AGENDA ITEM 6

RESPONSE TO CNPA

Response to Cairngorms National Park Authority

This document responds to the Cairngorms National Park Authority's (CNPA) letter, dated 28th October 2014, requesting further information on a number of topics relating to the River Pattack Hydro Scheme planning application [Application Reference 14/02344/FUL] [CNPA Reference PA-272].

Figure 1: Sketch showing vegetation management and indicative temporary junction widening required at the entrance to site from A86

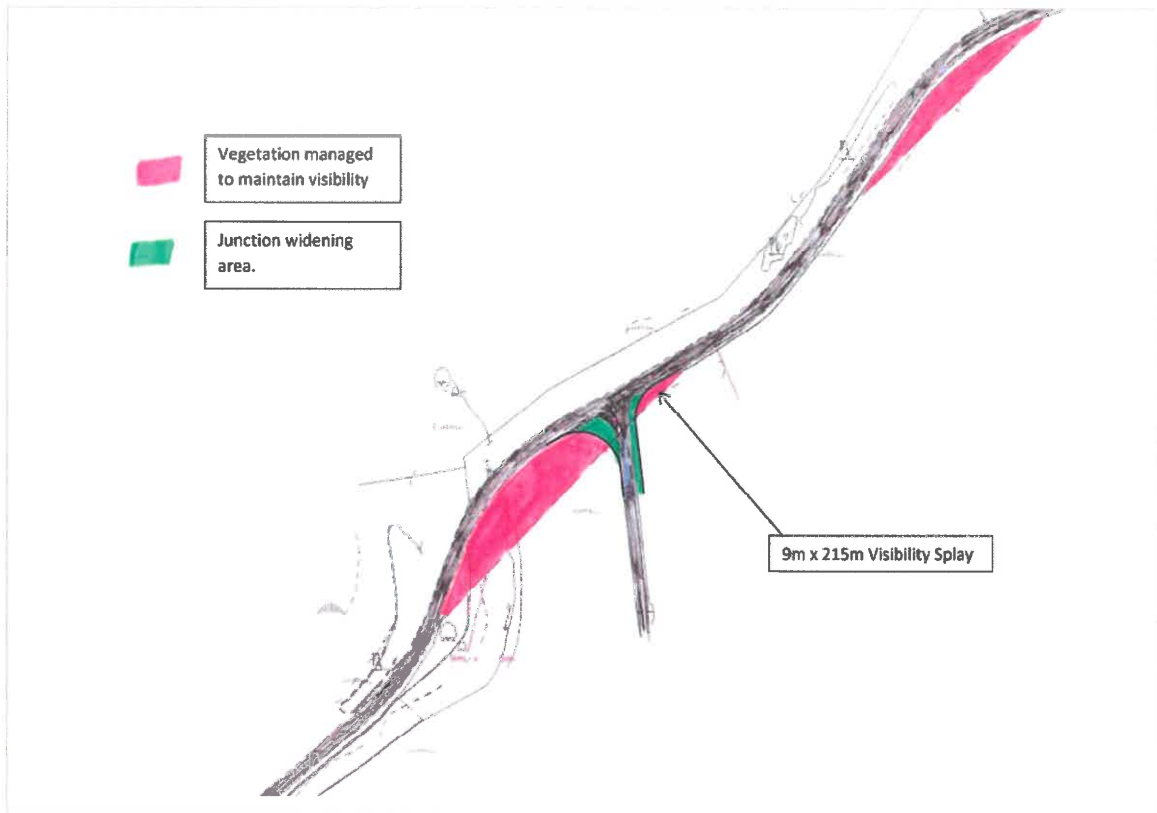
Objection 1: Access onto A86 – details are required of the upgrading of this junction and these details to be appropriate to the small scale landscape character of this area (for example avoiding the use of kerbed radii) and to include any post development restoration that may be required.

The A86 junction will be the primary access and egress point from the main road. An important issue to consider is the existing amount of room/width available in the turn off area immediately off the A86. A construction requirement will be to minimise the risk of large vehicles parking stationary on the A86 whilst waiting to gain entry into the site. To this end the requirement would be to ensure enough area is available for two 40' articulated sized vehicles/low loaders to comfortably stand stationary in the area immediately adjacent to the A86. In this case, if a lorry was waiting to pull out of the site onto the A86 to go in the Dalwhinnie direction, this would not prevent a lorry pulling into the site thus ensuring adequate safety levels for the A86 general traffic.

Any expansion of this track entrance area would be carried out in line with the recommendations outlined in the Traffic Assessment (Appendix 3.2 of the original Environmental Statement). A minimum curve radius of 15m would be required to provide an adequate turning area, and would be suitably surfaced to provide sufficient grip. Aesthetically compromising kerbed edgings would not be required. However, hidden pin kerbs that finish flush with the new surface level would be recommended and these could be wooden if appropriate.

Any expansions to and alterations of this type would be reinstated to their former condition at project completion. For information, Figures 2 – 4 below, include photographs of the existing entrance way. For reinstatement to happen effectively, a full survey of this area will be undertaken during the post-consent detailed design stage, which will allow the existing ground levels to be pin-pointing. It is suggested that a planning condition is created to cover reinstatement in accordance with detailed plans to be agreed.

A further consideration is the level of advanced warning for A86 traffic to warn general traffic of the presence of turning construction traffic at the junction. This will be achieved through the provision of appropriate signage in accordance with the relevant and current traffic regulations by a suitably competent contractor. Visibility risk mitigation would also be carried out in line with that recommended in the Traffic Assessment (Appendix 3.2 of the original Environmental Statement).

Finally, visibility at this junction would also need to be improved, with particular regard for the requirement of a visibility splay of 9m x 215m at the entrance. This would be achieved and maintained by controlling vegetation growth within the splay to prevent visibility from being obscured (see Figure 1, below).

Figure 5: Sketch showing how a new footpath (red dashed) could link up the existing footpath (solid red) and tracks (blue solid) on FCS land with the existing tracks on Ardverikie Estate (blue solid), to allow continuous pedestrian access to the Falls of Pattack

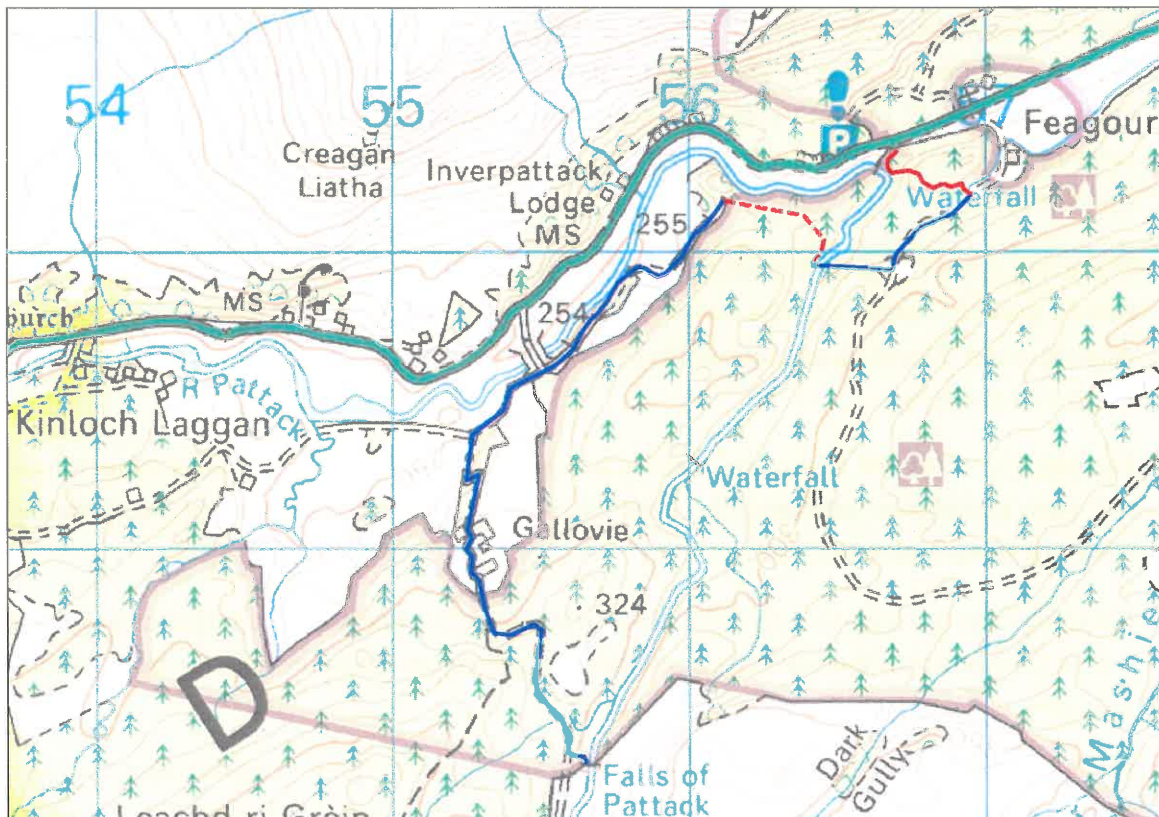
Objection 2: Site Establishment Area close to bridge over River Pattack - information is required on the provision of a small, informal car park in the general area to enhance public access post development including information on signage and interpretation.

Further detail from CNPA: It is understood from previous correspondence that the agent is willing to actively look at this point, presumably in full consultation with relevant roads authorities too, in order to establish the potential for some additional parking in the vicinity.

The provision of informal car parking facilities has been discussed at great length with Ardverikie Estate, Highland Planners and CNPA representatives, to which a number of significant risks have been raised - most notably: overnight camping; dumping of derelict vehicles; and general littering.

It is understood that the background aim of this provision is to improve access to the Upper Falls (Falls of Pattack). Instead of meeting these aims by the provision of new car parking facilities it is now proposed these aims can be achieved by focusing effort in linking the existing pedestrian access tracks on Ardverikie Estate, which lead to the Falls, with the existing car park and footpaths at NRG NN 567 903, on neighbouring Forestry Commission Scotland (FCS) land.

Bearing in mind the above, an indicative proposal would be to:

- formalise an unsurfaced footpath, connecting the kissing-gate at the end of Ardverikie's track (NGR NN 561 902), across heather moorland, to the bailey bridge (or similar) across the River Pattack on FCS land (a distance of some 500m);
- from here walkers would be directed to join the Forestry track, and lead off onto the existing footpaths (NGR NN 569 902) down to the existing car park;
- include new appropriate waymarking from the FCS car park to the Falls of Pattack (a distance of some 4.3km);
- see Figure 5, below for further details of the anticipated elements.

Figure 6: Plan showing riparian region to the north of site establishment area – the green hatching shows the area to be planted

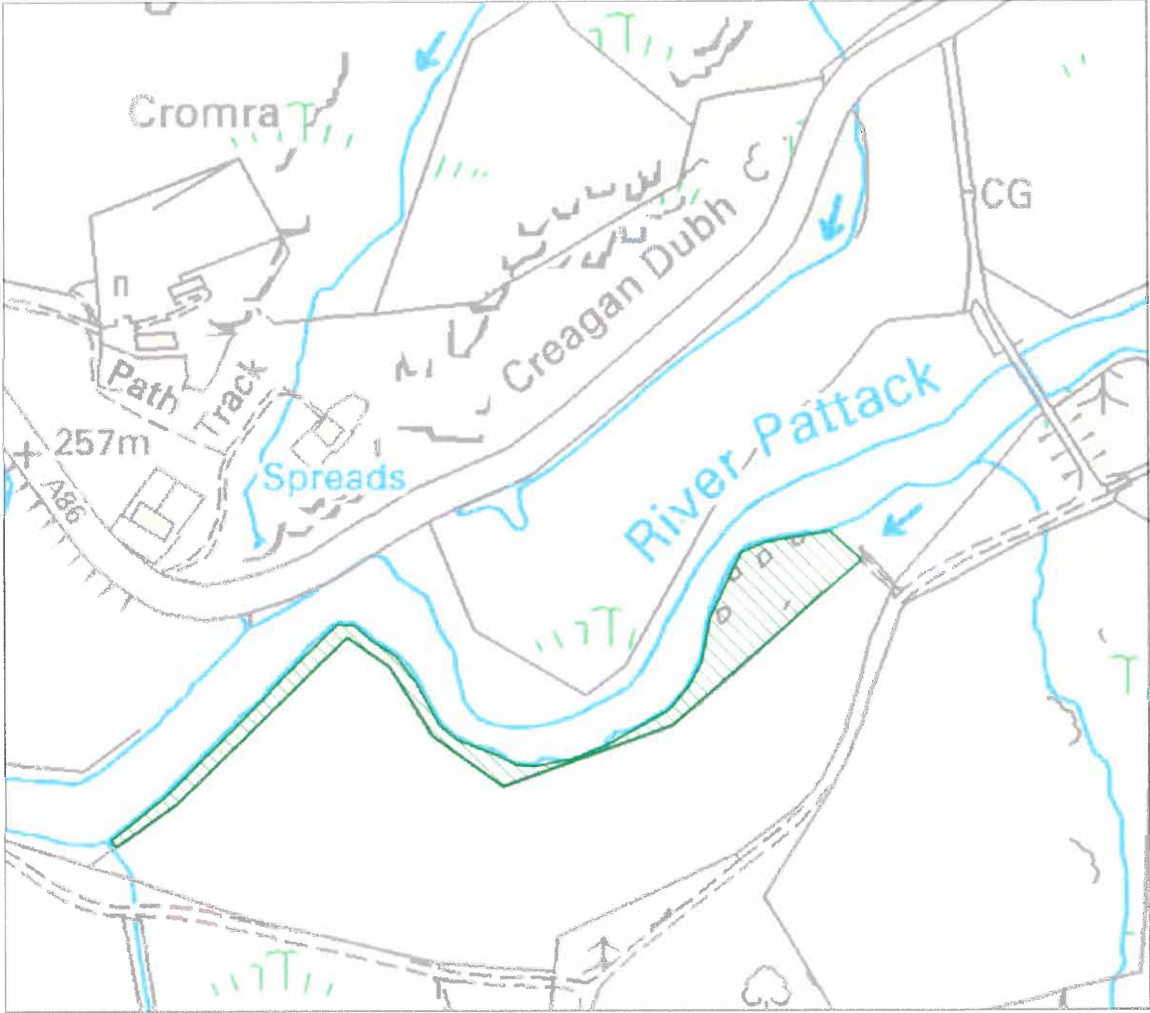
Objection 3: Second site establishment area beside River Pattack within National Park - details (including site area, species, number, spacing and maintenance) are required of provision of riparian tree planting here to enhance the existing tree cover.

Further detail from CNPA: It is also understood from previous discussions that the agent is willing to meet with our Landscape Advisor and planning representatives to discuss what type of planting/areas would be suitable.

Following a site visit with CNPA planning and landscape representativeness, a commitment is now made to strengthen the existing scattered woodland cover in the riparian zone with additional tree planting, between the river bank and fence line along the stretch of this site establishment area, see Figure 6 below. It should be noted that part of the eastern section of this site is an active gravel bank which is not suitable for tree planting.

The species choice will reflect the existing tree cover and likely comprise of the following species – Common alder (75%), Downy birch (15%), Rowan (5%) and Grey willow (5%). Planting will be in discrete species groups; the spacing will be random but at an average stocking density of 2,500 stems per ha. It is estimated that 500 trees will be planted in this riparian zone.

There is a stock fence on the south side of the site, but there is no fence close to the river. Due to periodic flooding of the lower lying land, the erection of deer fences or upgrading of existing stock fences is considered impractical. Planted trees will therefore be protected using tree shelters.

The planted trees will be maintained for a period of 5 years when it can be expected they will have established satisfactorily. This will include controlling competing vegetation and the replacement of failed trees.

For this planting zone, tree planting can occur during the construction phase and will occur within 12 months of the start of construction, ensuring an optimum time for tree planting is available.

Figure 7: Plan showing 'Sanctuary Road' – green hatching on both sides of track shows indicative areas to be planted

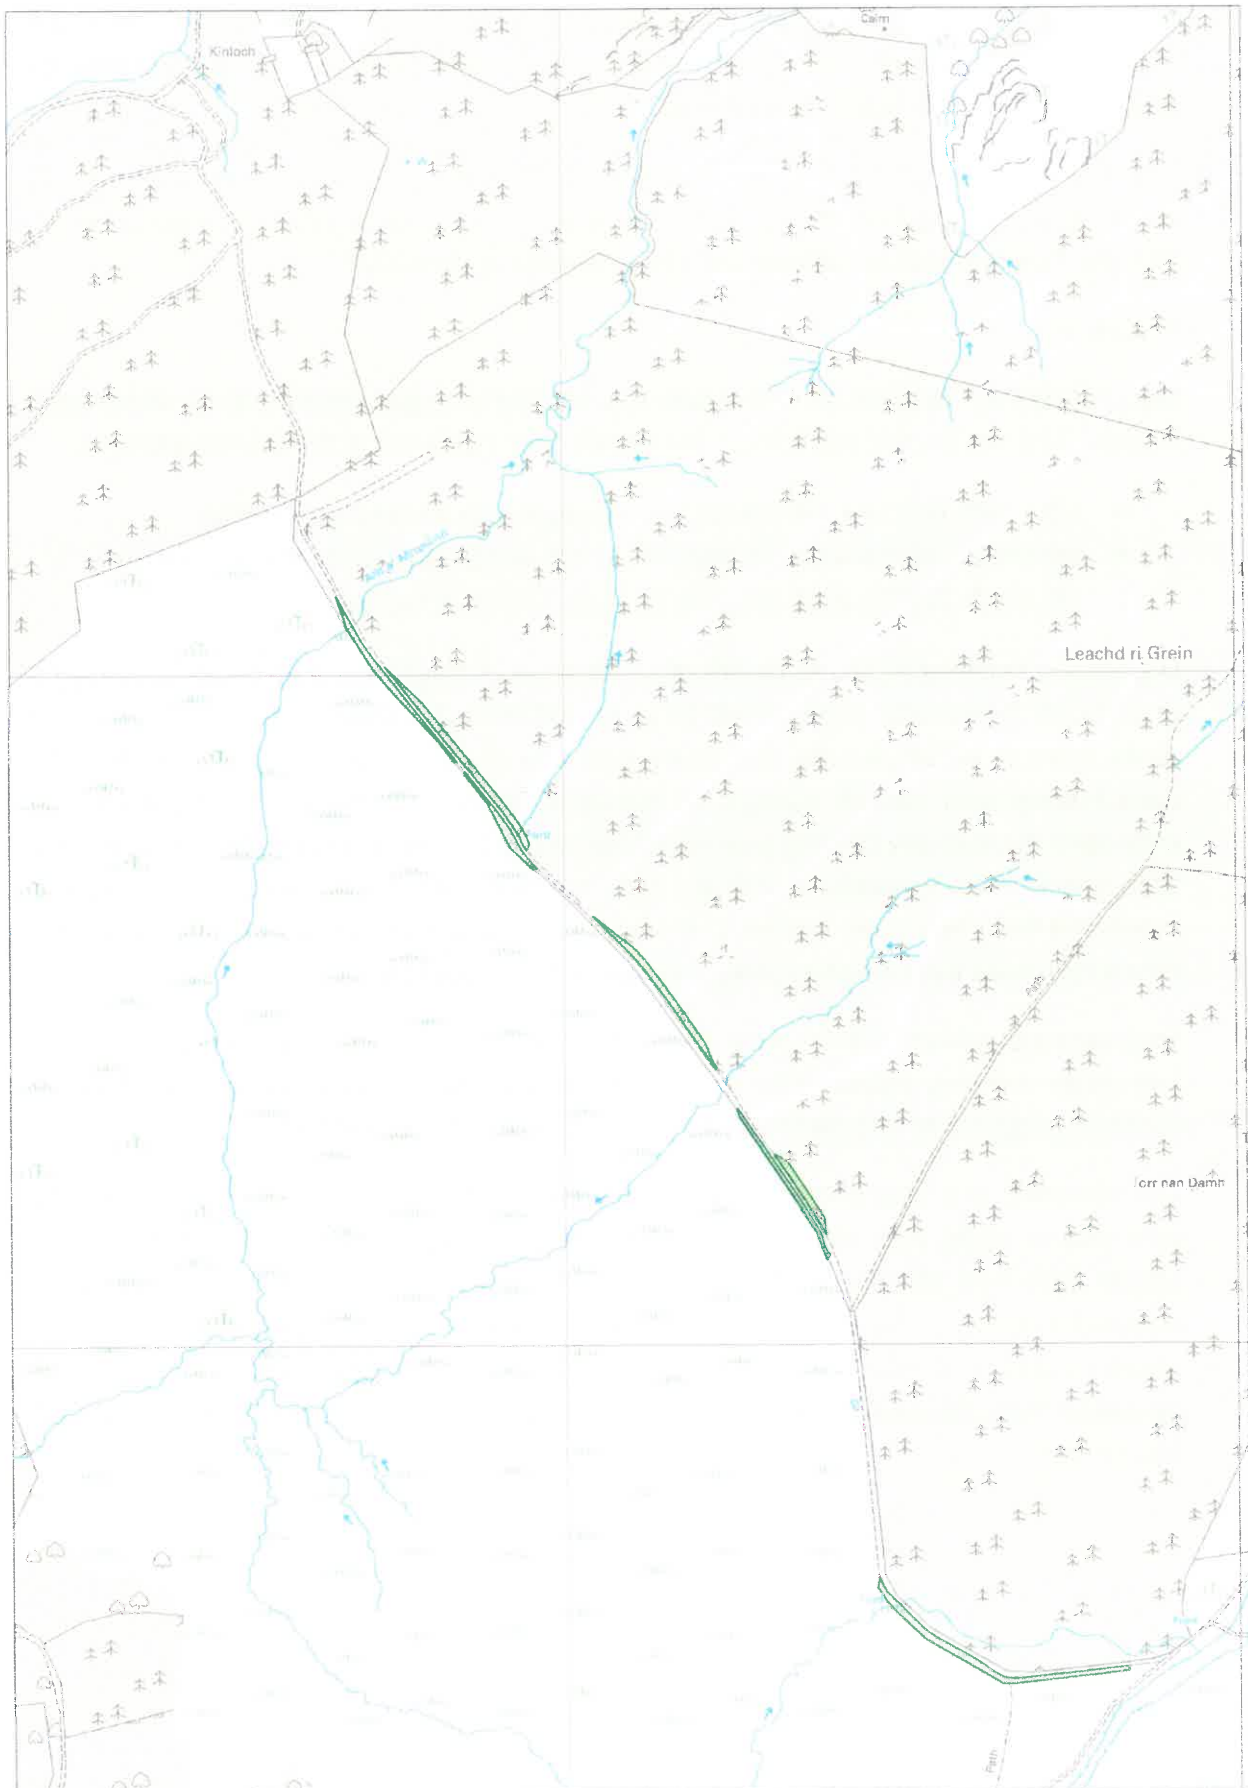
Objection 5: Pipeline Route and temporary access track; details (including site area, species, number, spacing and maintenance) are required of planting of native broadleaf trees to be carried out along this western edge of the National Park.

It is also understood from previous discussions that the agent is willing to meet with our Landscape Advisor and planning representatives to discuss what type of planting/areas would be suitable.

Following a visit to site with the CNPA planning and landscape team, a commitment is now made to provide some tree planting along the estate track known as the 'Sanctuary Road'. This is designed to provide interest at this edge of the National Park, and some softening of views to the construction works reinstatement corridor on this part of the site. Planting will occur on the west of the estate track up to the existing deer fence, and east of the track for a distance of up to 10m. Importantly, planting will not be designed to be dense in order to allow the views beyond still to be seen, and specific stretches where the topography allows for panoramic views will be left unplanted to allow wider unobstructed views of the distant vista.

The following species are proposed – Downy birch (75%), Scots pine (10%), Rowan (10%) and Eared willow (5%). Tree planting will be in small groups to avoid a hedge effect. Planting sites will be carefully selected to avoid areas where the peat depth is greater than 50cm. The tree spacing will be random but at an average stocking density of 2,500 stems per ha. It is estimated that around 1,500 trees will be planted as a result of this commitment.

Despite the existing deer fences it is probable that deer will have access to the proposed planting site. It is proposed, therefore, to protect all planted trees with tree shelters.

Maintenance of the planted areas will be undertaken for 5 years after planting. This will include control of competing vegetation and the replacement of failed trees. However, given the altitude of this area, no commitment is made to maintenance after this initial period if the trees do not establish within this timeframe.

For this planting zone, and after discussion with CNPA landscape advisor, planting will occur within 12 months after commissioning, to ensure that construction is not limited by the new planting on this important access route, and to prevent any damage to the new trees occurring during the construction phase.

Full details, including a construction method statement, will be provided to Highland Council prior to the beginning of planting, but an indicative layout for discussion is shown in Figure 7 below.

Figure 8: Dalwhinnie to Ben Alder Core Path (Route 215) management plan during construction

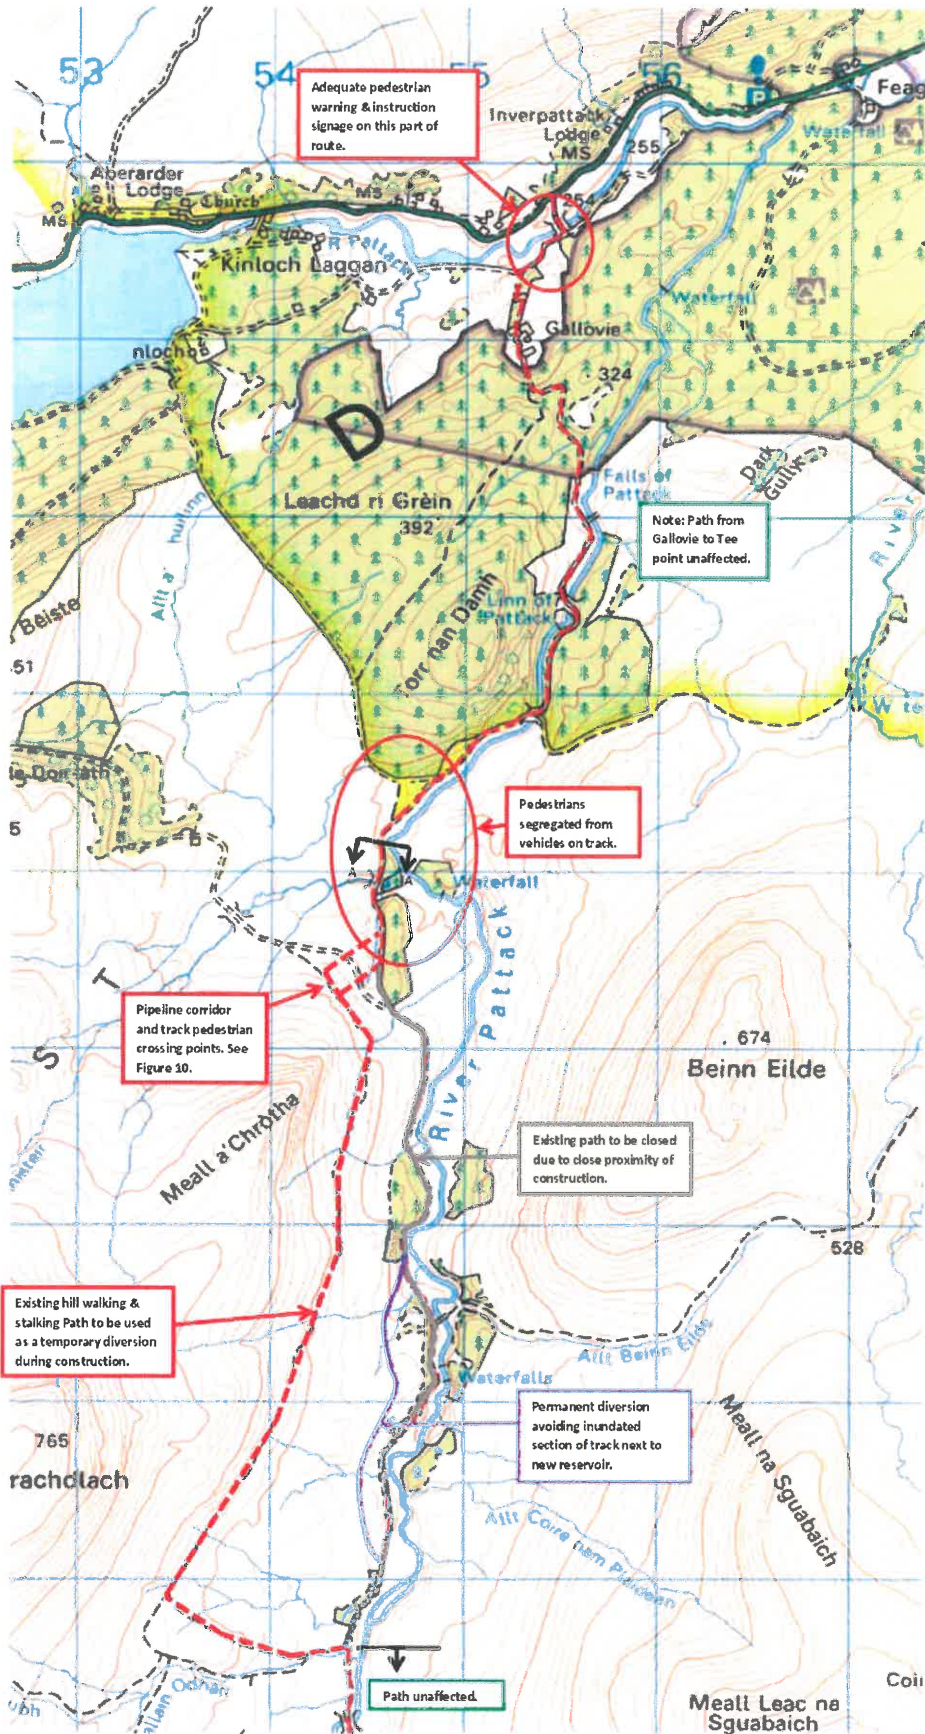
Objection 9: Public Access – confirmation that public access and core paths will be unaffected by the proposed development, in particular the core path running from the Dalwhinnie/Ben Alder area to Pattack.

Further detail from CNPA: It is our understanding that existing core paths within the National Park will be unaffected - confirmation of this and any arrangements to ensure all public access is maintained on the core path from Dalwhinnie/Ben Alder area to Pattack is required.

Only one Core Path [Dalwhinnie to Ben Alder – Route 215] is located within the project area itself. Of the stretch within the Cairngorm National Park, only one short section (approximately 600m) is directly affected by the proposed construction works. However, given the interest in the continuation of the entire route this report deals with provisions intended to allow continued use of this Core Path throughout the life of the project.

A pedestrian plan along the Core Path is included in Figure 8 and contains five main points:

1. The footpath diversion proposal along the existing hill walking and stalking path. This will allow the closure of the existing estate track to the public which runs immediately alongside the River Pattack from upstream of the Sanctuary area up to beyond the reservoir impoundment area and is required due to the very close proximity of construction work in that area. The proposed path closure is shown in grey, with the diversion route shown as a red dashed line. At the downstream end of this diversion a temporary path will cross the pipeline corridor and existing access track to allow reconnection with the existing route. One of two proposed crossing points will be used and the position of the pipe laying front will influence which route should be adopted and this will be managed by the Construction Contractor. Please refer to the crossing point arrangements attachment for further details of how this will work in practice (see Figure 10).

2. The permanent footpath diversion to follow new track – shown in purple on Figure 8. The new reservoir will inundate a section of the existing estate track. It is therefore proposed to permanently divert this track onto higher ground. This will allow continued usage by the estate and the public.

3. There is a short stretch of existing track that will likely be used for both plant access and pedestrians near to the track junction in the middle of the site and is circled in red on the plan (Figure 8). A typical section through the track is also included (Figure 9) to show this arrangement. It should be noted that the existing estate track may require some improvement and/or widening to accommodate these requirements.

4. At the northern end of the site, 'Gallovie' bridge and the adjacent short stretch of track will be used by both construction traffic and pedestrians. Width restrictions on the bridge will therefore require suitable signage to warn pedestrians of construction traffic as they share this area, however pedestrian segregation may be possible on the track to the south side of the bridge before the path turns off up to Gallovie Farm (which will not see construction traffic). The area this point refers to is circled in red at the top of the plan (Figure 8).

Both areas are noted on the plan in the green boxes (Figure 8).
